**STAFF REPORT
PLANNING DIRECTOR DECISION**

DATE: July 2, 2013
FILE NO.: WAP-13-03
REQUEST: Water Resource Area (WRA) permit for single-family detached house on lot of record at 4744 Chestnut Street
PLANNER: Tom Soppe, Associate Planner

SITE PLAN

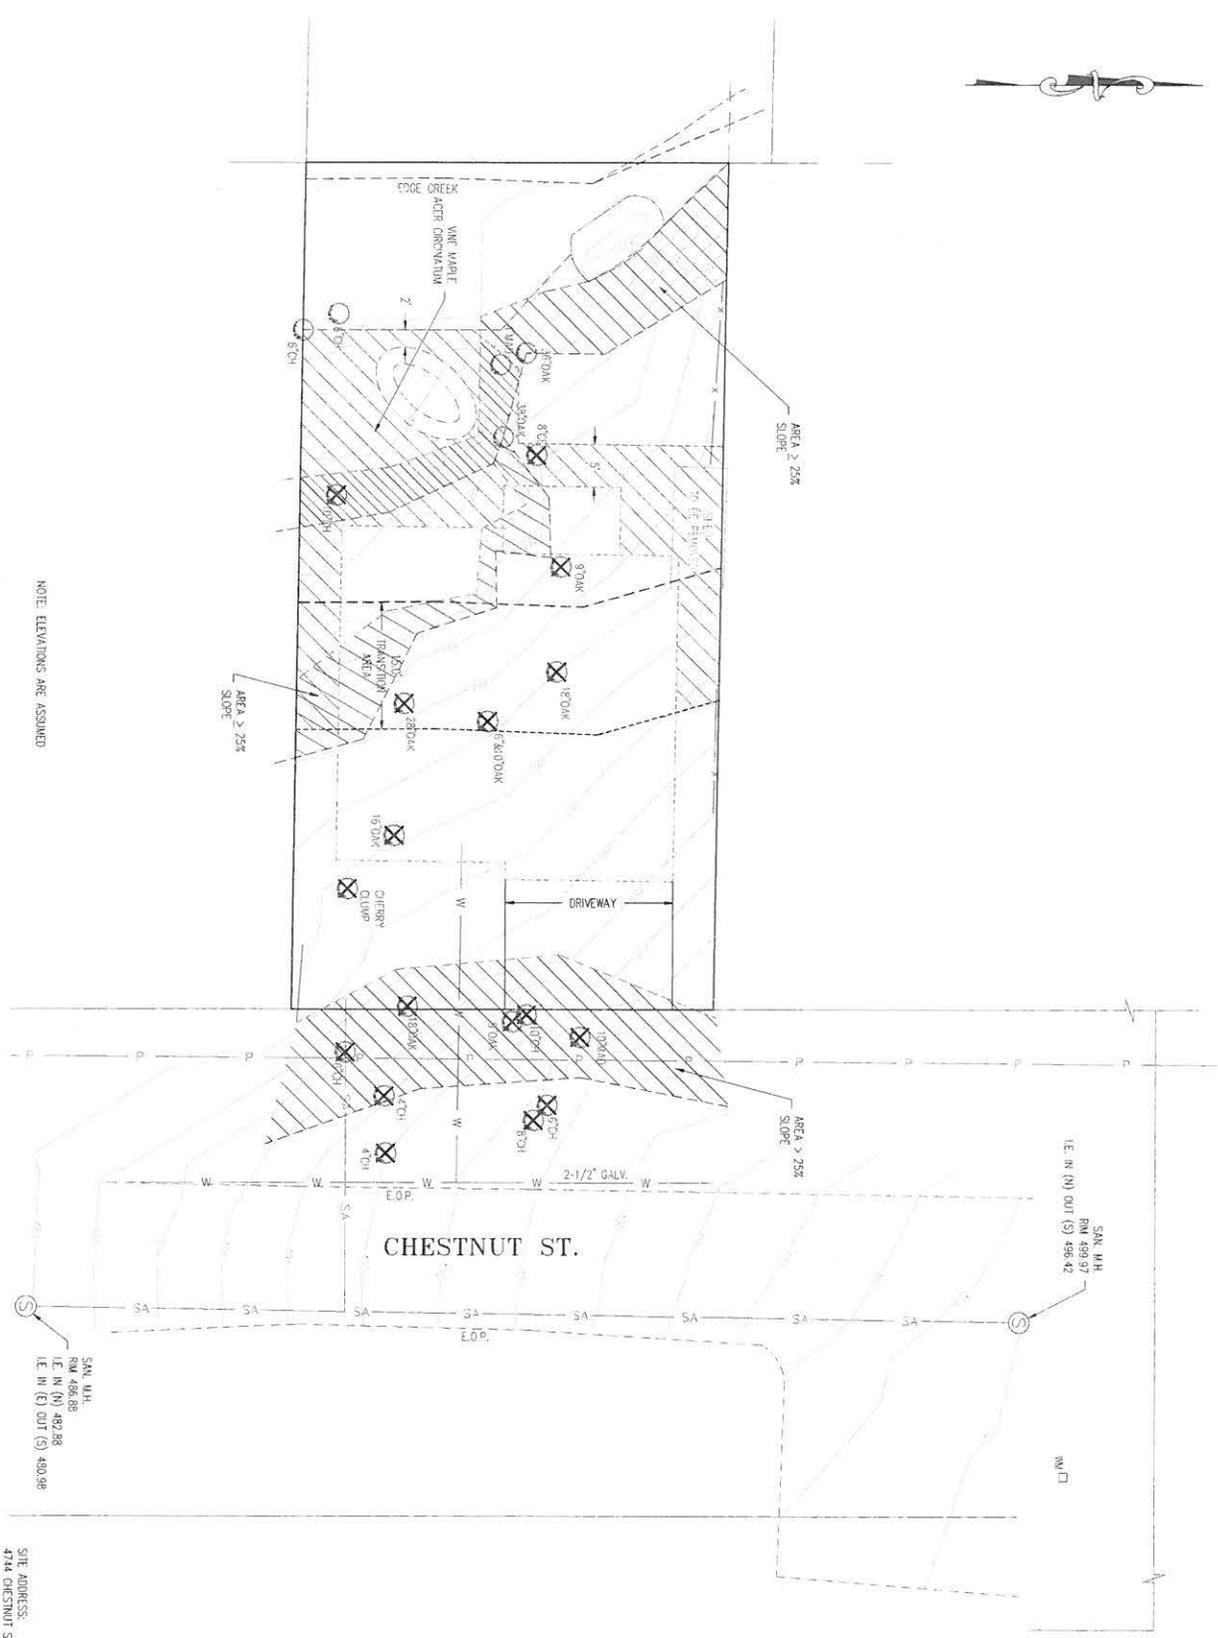
3. Construction Fencing. Construction fencing shall contain all areas of the water resource transition and setback not proposed for construction disturbance, as delineated on the Site Plan on Page 40 of Exhibit PD-5. In addition, areas within the proposed disturbance area that contain trees not identified for removal on the site plan shall be fenced as approved by the City's arborist

Staff Response 12: The applicant proposes a silt fence 25 feet from the channel as seen in their response to this criterion Page 45 of Exhibit PD-5, but per this criterion the fence should also include areas not proposed for disturbance that are outside this 25-foot buffer but within the water resource area, as shown on the Site Plan on Page 40 of Exhibit PD-5. Condition of Approval 3 requires this. Condition of Approval 2 requires that areas of the water resource area to remain undeveloped, which will match the easement boundaries required in this condition, be marked at all boundary changes and at 30- to 50-foot intervals. Staff finds that the criterion is met upon the inclusion of conditions 2 and 4.
